**STATE OF NEW HAMPSHIRE  
INTER-DEPARTMENT COMMUNICATION**

**SUBJECT** Dredge & Fill Application  
Derry-Londonderry, 13065  
DES File #2018-03134

**Responses to NHDES Jan 2019 Comments on the Exit 4A Conceptual Wetland Application  
(Including 1-23-2019 NHDES Meeting with NHDOT)**

**WETLAND IMPACT PLAN**

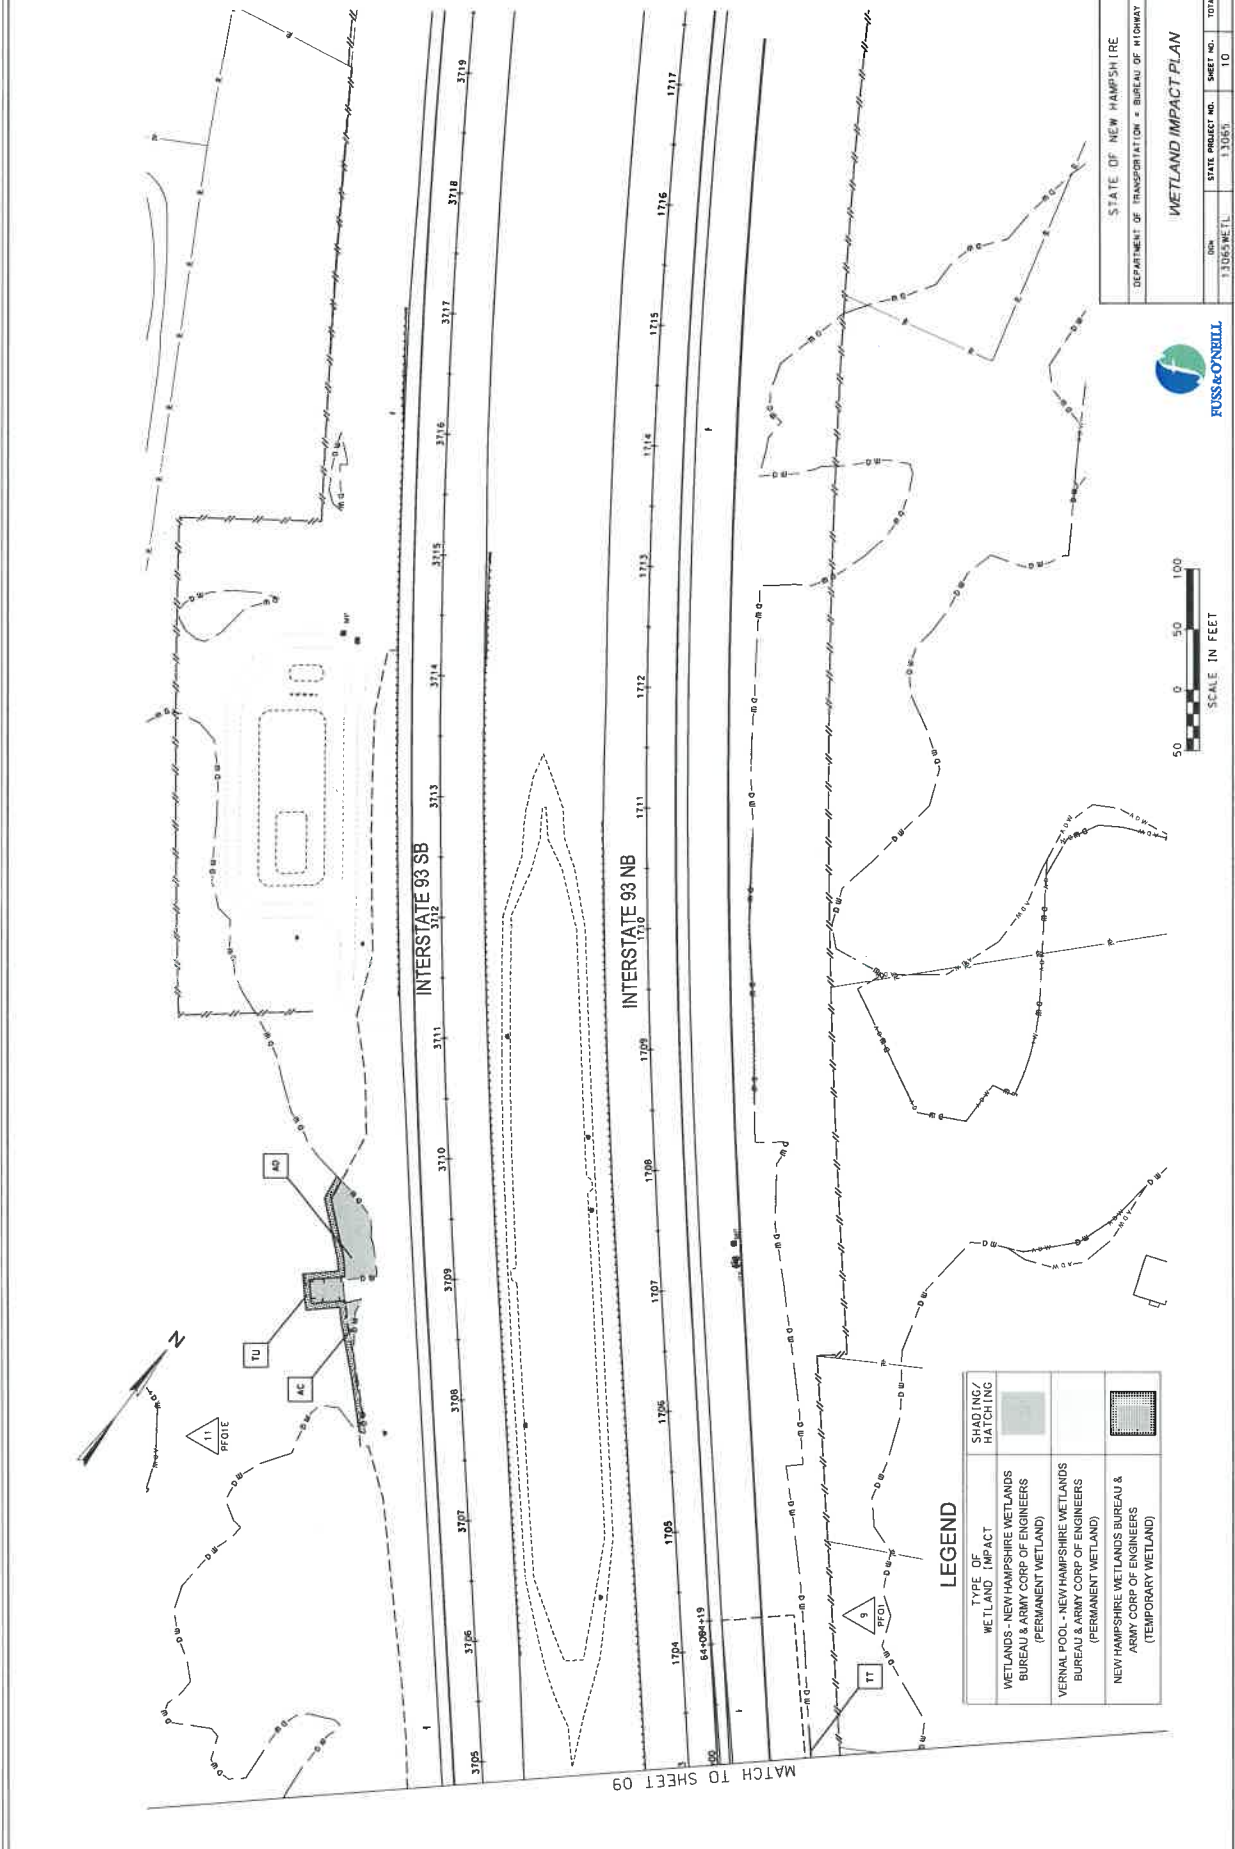
27. Note sheet 7 matches with sheet 10 to the east instead of sheet 6.

*We do not believe that the pond 1670 will need to be redesigned. However, a berm has been added to prevent the pond discharge from entering Vernal Pool 3 (sheet 7 of the Permit Plan set). This has resulted in an increase in direct impacts (fill) to Vernal Pool 3.*

STATE OF NEW HAMPSHIRE DEPARTMENT OF TRANSPORTATION & BUREAU OF HIGHWAY DESIGN
<b>WETLAND IMPACT PLAN</b>
DATE: 1306SWEL
STATE PROJECT NO.: 1306S
SHEET NO.: 22
TOTAL SHEETS: 28

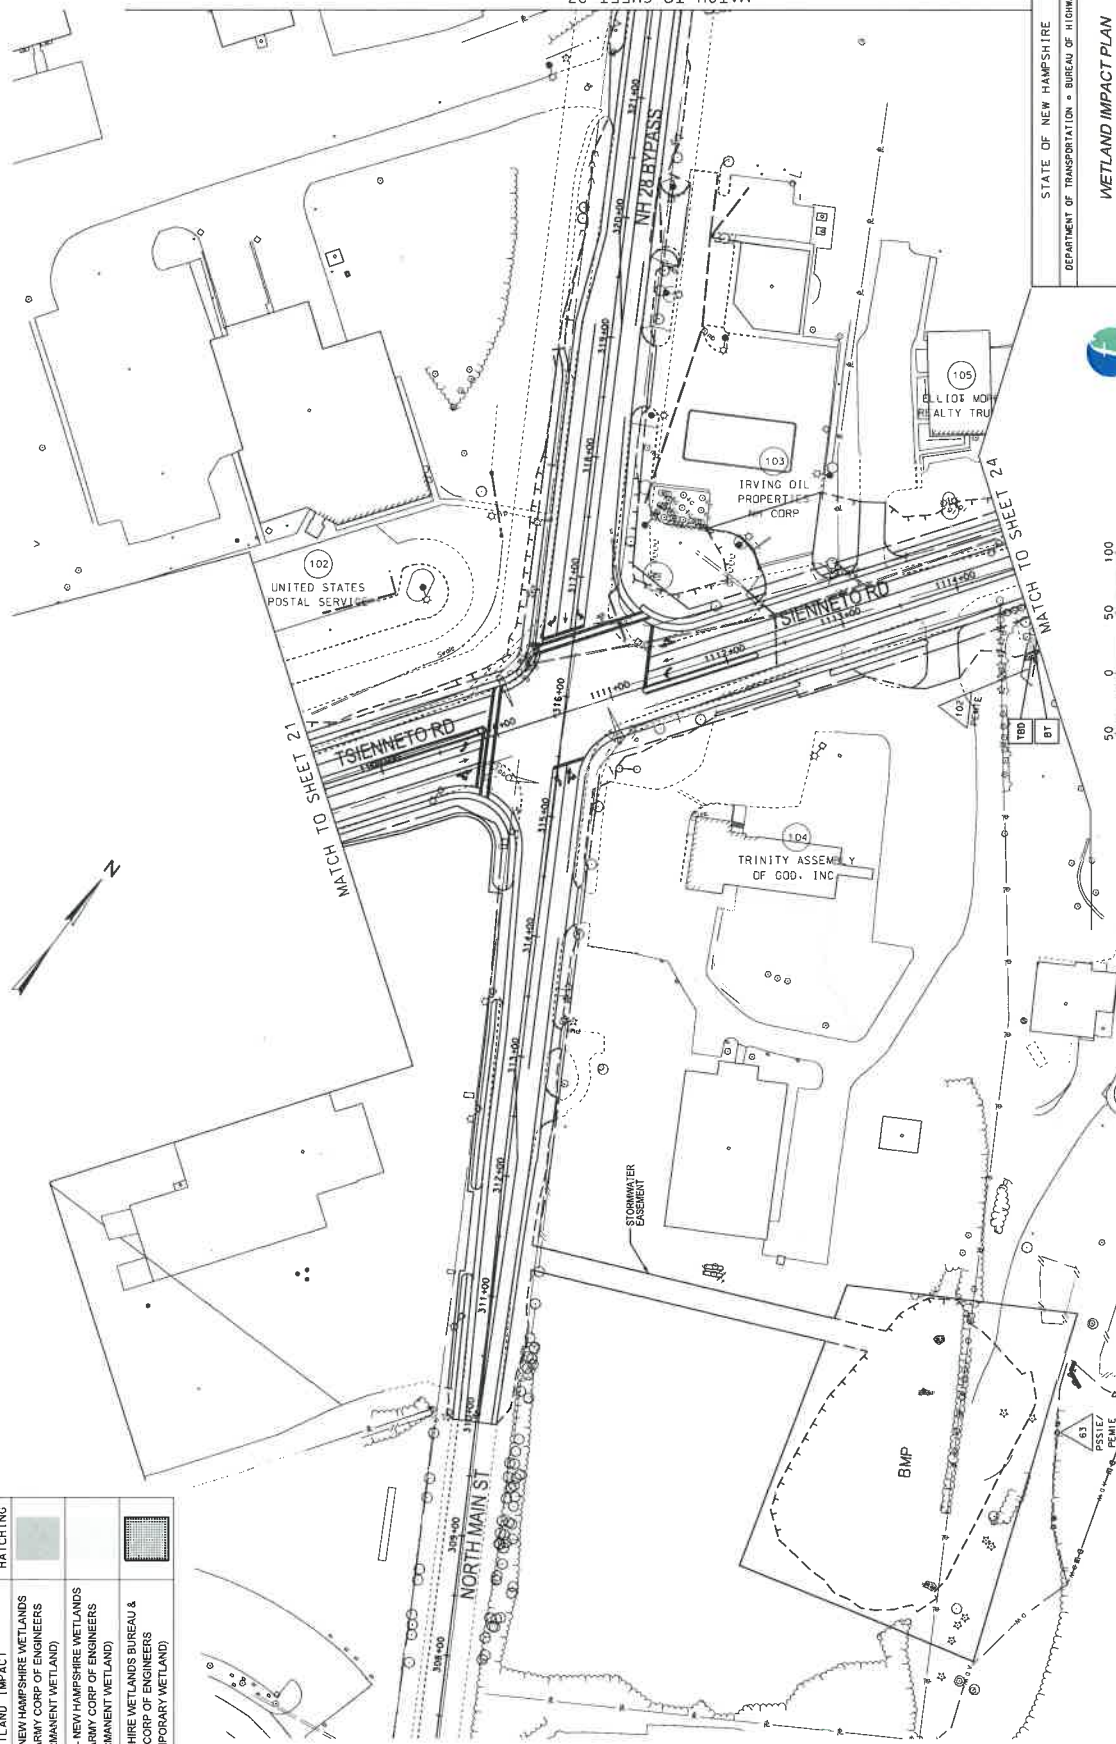
34. Sheet 22 impact to vernal pool appears to be a probable outlet area for drainage where the impacts are likely to be more than the initial construction. Station 1139.

*The vernal pool impact shown was based on the topography, and is not related to a drainage outlet. However, Fuss & O'Neill have been able to refine the design in this location to eliminate permanent fill impacts to this vernal pool (VP11), which is now shown on Sheet 25, although some temporary impacts will occur. The stormwater swale that was shown adjacent to the vernal pool has been eliminated from the design. A small impact to the wetland containing the vernal pool (Wetland 54) will occur from guard rail installation at the improved intersection of Tsienneto Road and Barkland Drive.*
